FORMAL OBSERVATION AND SUBMISSION

Case Reference: PAX16.324387

Subject: Proposed RWE Renewables Ireland Limited — Muingmore Wind Farm

13 Wind Turbines | 180m Tip Height | 74.1–91MW Installed Capacity | 35-Year Operational Life

Table 10 from Technical Appendix 5-3 (Bat Survey Report) — Autumn 2024 bat passes by detector. D.10 recorded 3,739 passes — 40.91% of all autumn bat activity on the entire site.

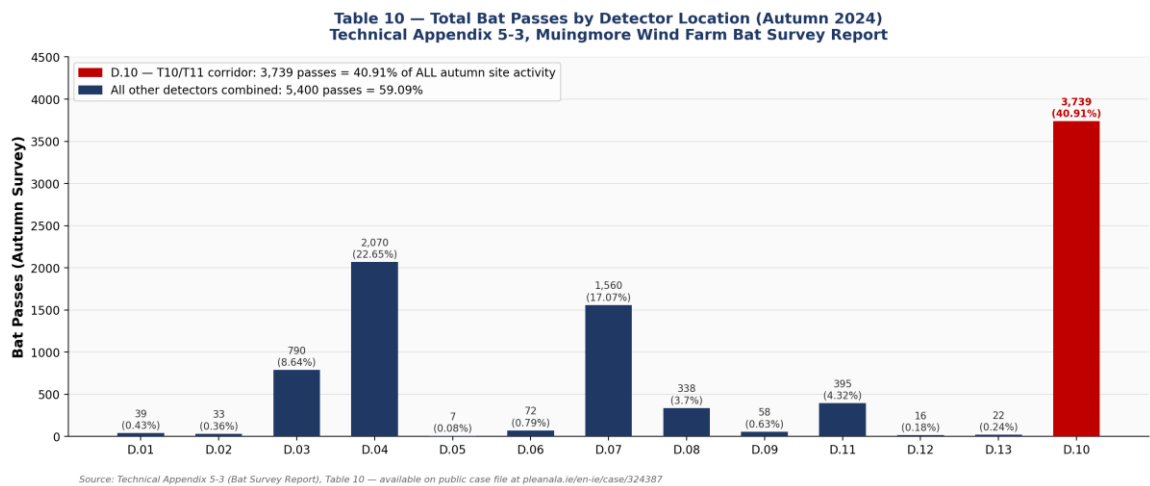
Rural West Environmentalists notes that the applicant's own reported seasonal totals for 2024 (autumn 9,139 passes, spring 2,832 passes, summer 2,058 passes) sum to 14,029 passes, which does not match the applicant's own stated overall total of 13,423 passes for that year — a discrepancy of 606 passes that the applicant's report does not explain. Rural West Environmentalists requests that An Coimisiún Pleanála require the applicant to reconcile this discrepancy, and to confirm the correct and final per-detector, per-season pass totals, before any determination is made.

The adequacy of the roost assessment is further undermined by the woodland edge bat activity concentrations identified at Detector D.10, addressed at Section 33.7.4 above. The applicant's own NatureScot-compliant guidance (the standard applied throughout the Bat Survey Report) requires a minimum 50-metre rotor-tip clearance buffer from woodland edges at turbines with demonstrated high bat activity. Rural West Environmentalists has verified that no such buffer has been applied or justified for Turbines T01, T02, T03, T10, T12, or T13, which Technical Appendix 5-3 Section 3.9 confirms directly correspond to the high-activity woodland edge zones. The applicant's failure to apply this buffer at the locations of highest recorded activity, without any site-specific justification, is a material omission from the Bat Survey Report.

Rural West Environmentalists requests that the Habitat Management Plan and Forestry Report be required to confirm whether any of the 13 proposed turbines are sited within or immediately adjacent to the forestry edge habitat at D.10 specifically, given that this single location accounts for over 40% of all recorded autumn bat activity on the entire site, and if so, what rotor-tip clearance from this specific high-activity edge has been applied. The combination of confirmed, dominant bat activity at this single location, the unexplained arithmetic discrepancy in the applicant's own seasonal totals, and the equipment failure at two monitoring locations during the autumn 2023 survey identified at Section 33.7.1 above, means the applicant has not demonstrated that turbine-specific collision risk at this critical forestry-edge location has been completely and adequately assessed.

33.8 Background Noise: Systemic Calibration Failures Invalidate the Entire Noise Baseline

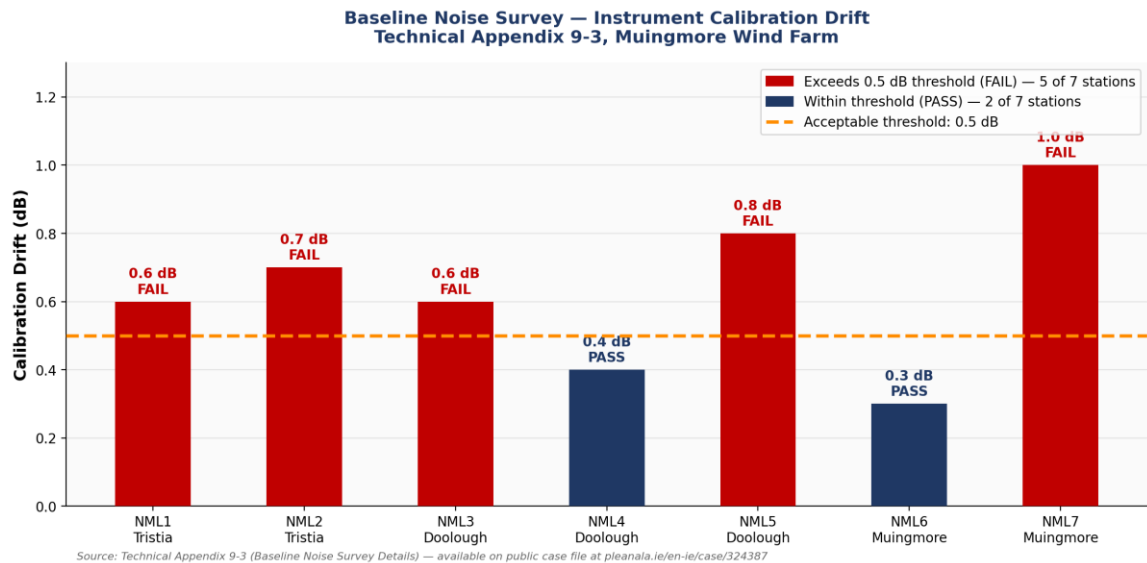
The Baseline Noise Survey Details (Technical Appendix 9-3) compiled by Bow Acoustics contains severe instrumentation errors that violate the Wind Energy Development Guidelines (2006) and the Institute of Acoustics (IOA) Good Practice Guide to the Application of ETSU-R-97.

Rural West Environmentalists notes that this directly contradicts the applicant's own Chapter 9 (Noise and Vibration) narrative, which asserts in its 'Assumptions, Limitations and Confidence' section that 'no significant information gaps were identified, and the assessment was undertaken in line with relevant standards and policy documents.' Rural West Environmentalists submits that an applicant cannot properly claim no significant information gaps exist in a noise assessment while, on the applicant's own underlying instrument records addressed below, five of the seven sound level meters used to establish that assessment's baseline failed to meet basic field calibration stability criteria.

33.8.1 Calibration Drift Exceeds the 0.5 dB Threshold at 5 of 7 Monitoring Stations
